Town of Hilton Head Island
Design Review Board Meeting
Tuesday, October 25, 2022 – 2:30 p.m.
AGENDA

a. *Drift Away, DRB 002527-2022* – Multi-family Renovation

DESIGN TEAM/DRB COMMENT SHEET

LANDSCAPE LIGHTING PLAN
 "DRIFTAWAY AT 25 LAGOON", 25 LAGOON RD., HHI, SC
 September 1, 2022
 SITWORKS DESIGN GROUP, LLC
 803-445-1839

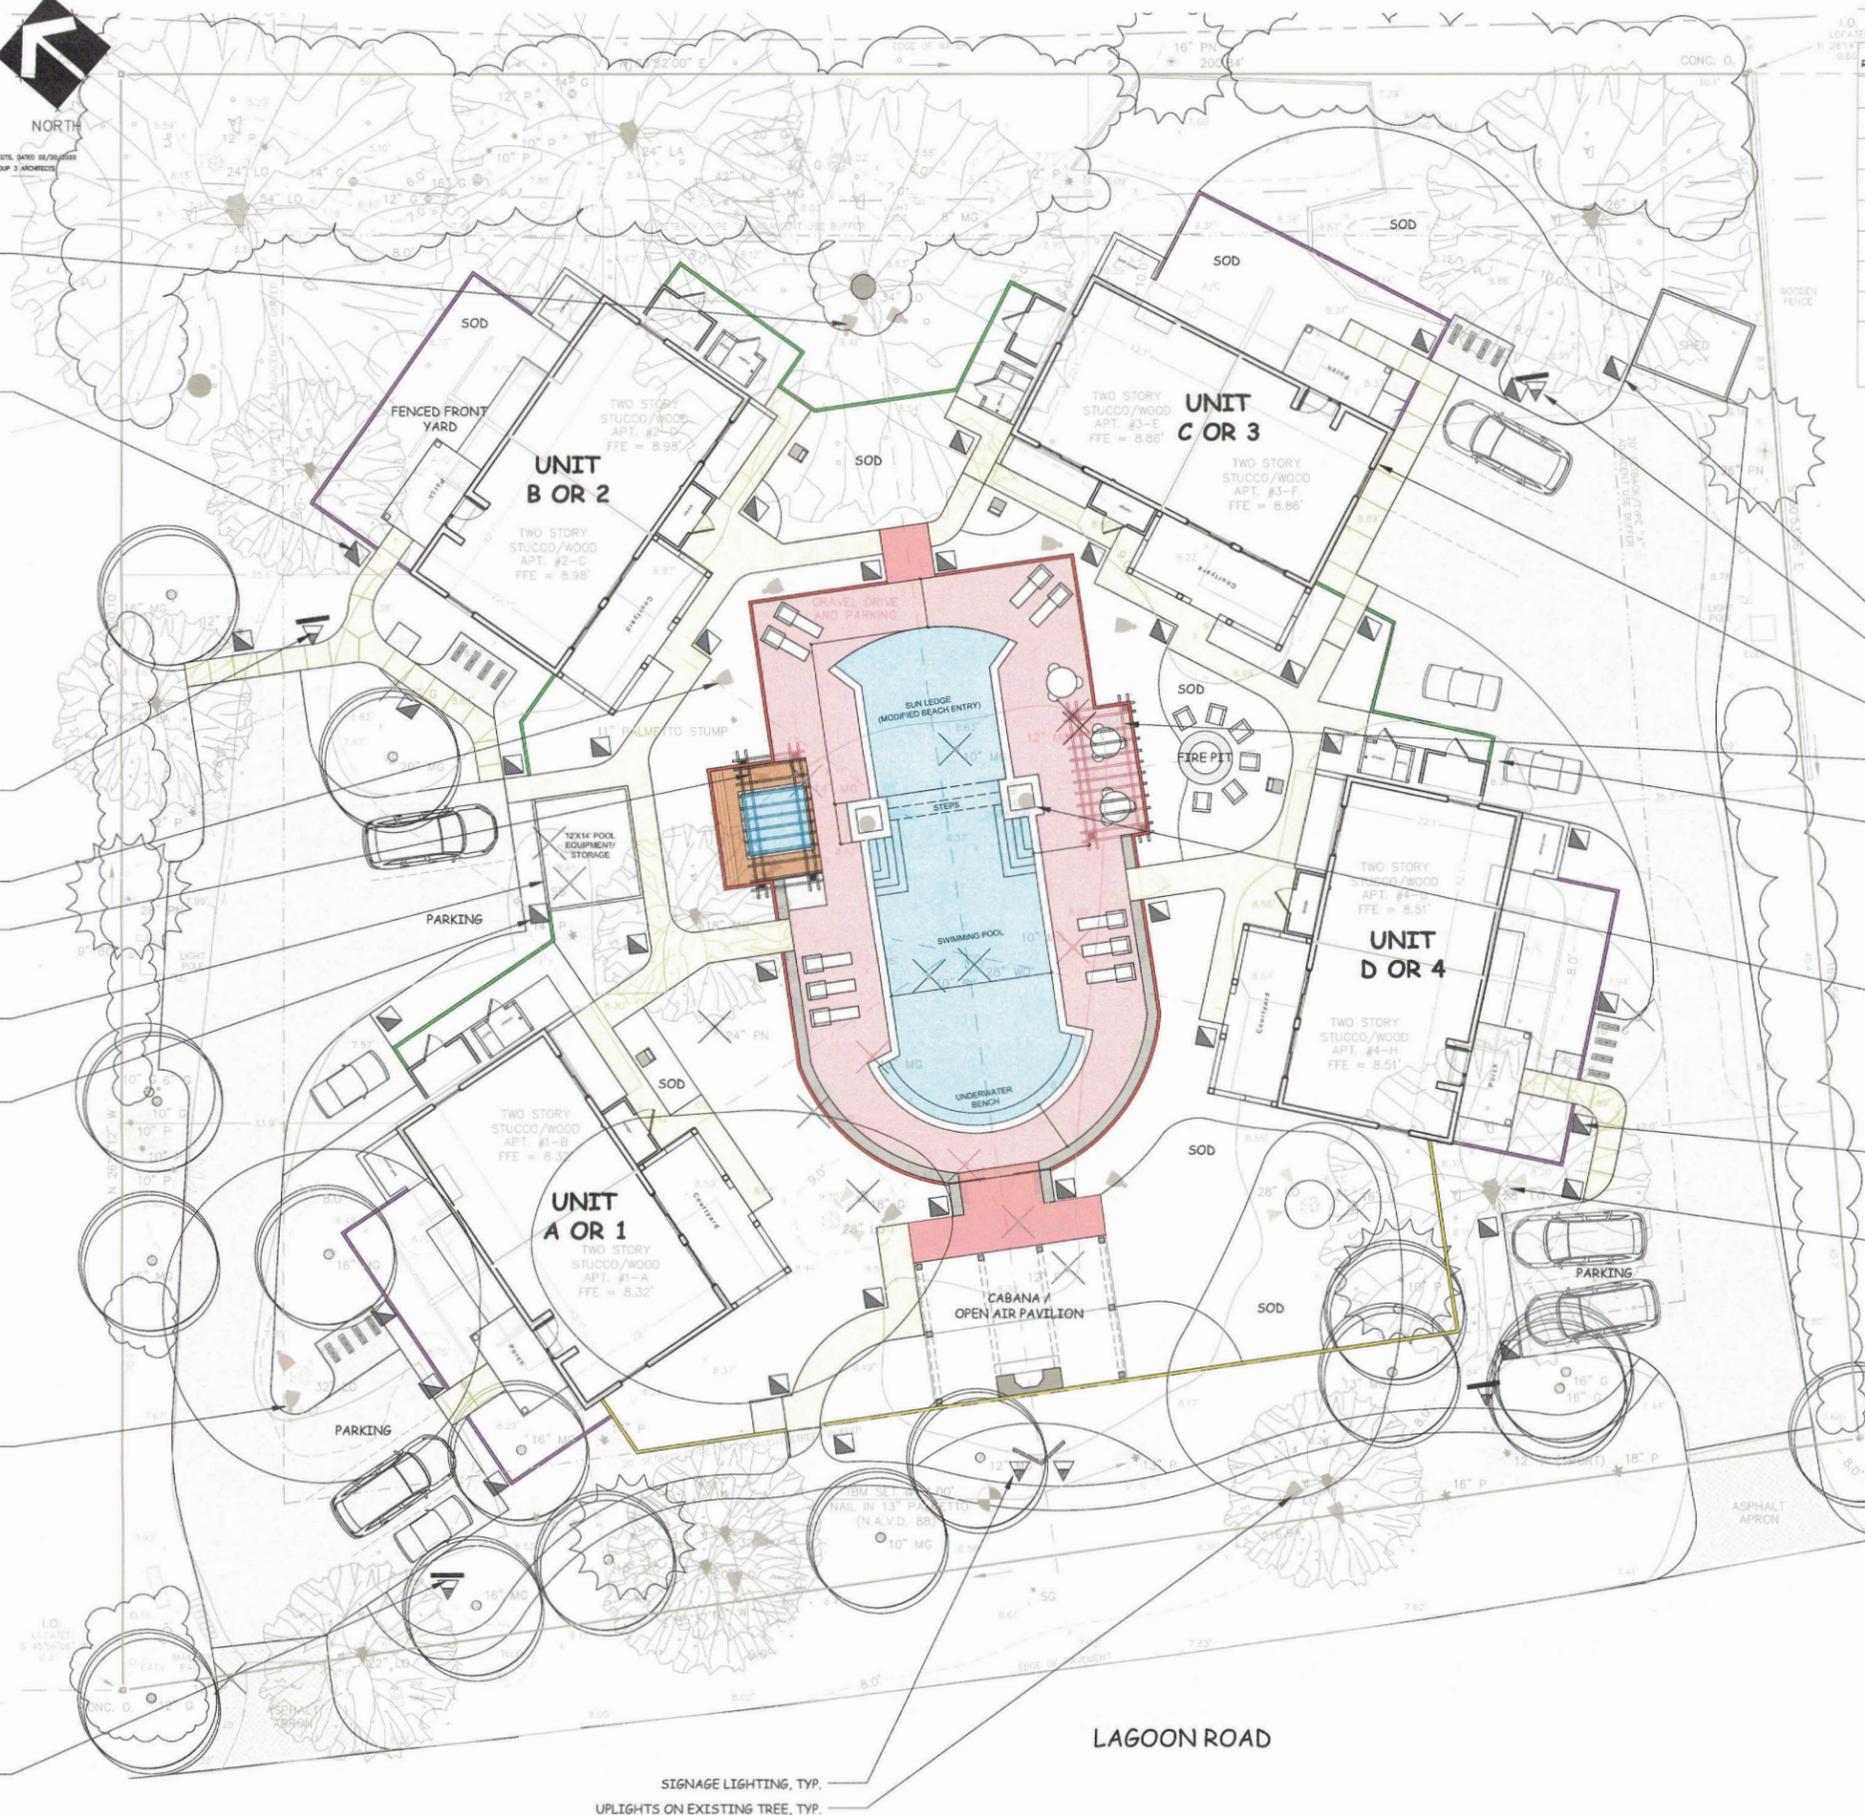
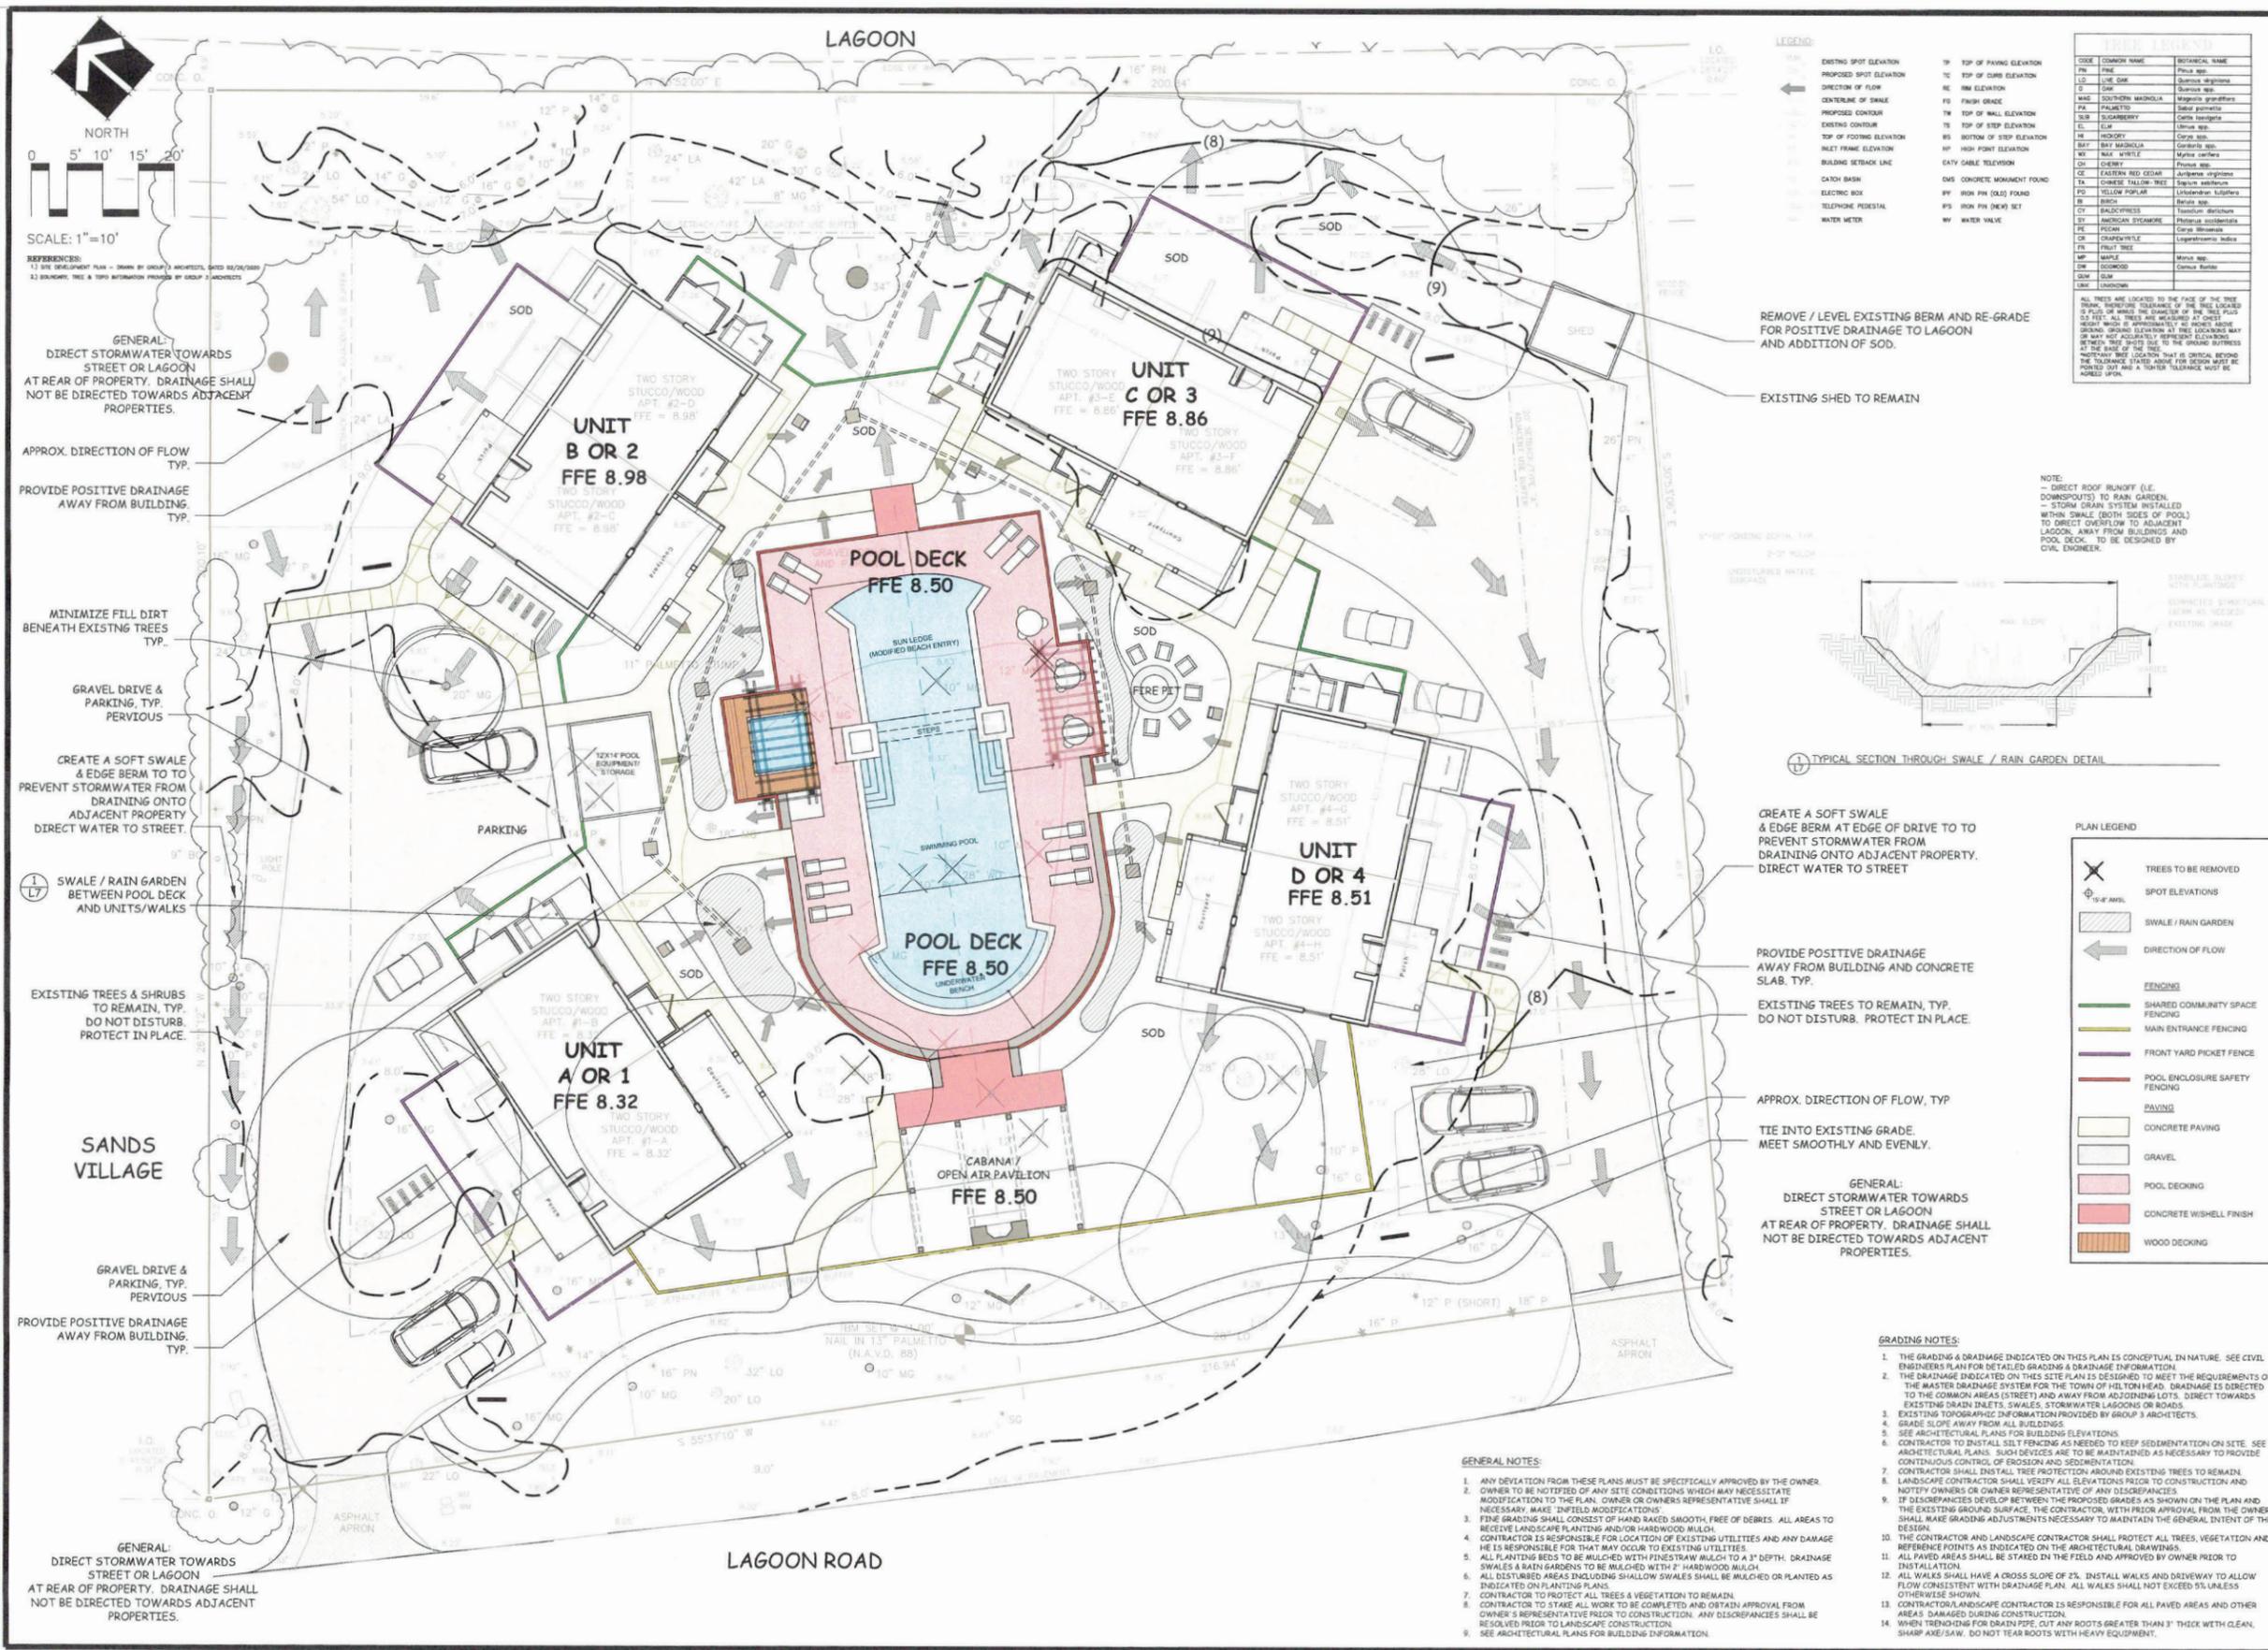
1. Provide an electrical conduit installation detail that protects tree roots for the tree uprights.
2. Remove all encroachments and improvements from the setbacks and buffers.
3. Limit new impervious coverage within the dripline of the specimen trees to 20% of the dripline.
4. Provide pre and post construction fertilization and mycor treatment for all specimen trees on the site.

DESIGN GUIDE/LMO CRITERIA	Complies Yes	No	Not Applicable	Comments or Conditions
An effort has been made to preserve existing trees and under story plants	<input type="checkbox"/>	<input checked="" type="checkbox"/>	<input type="checkbox"/>	Provide an electrical conduit installation detail that protects tree roots for the tree uprights.
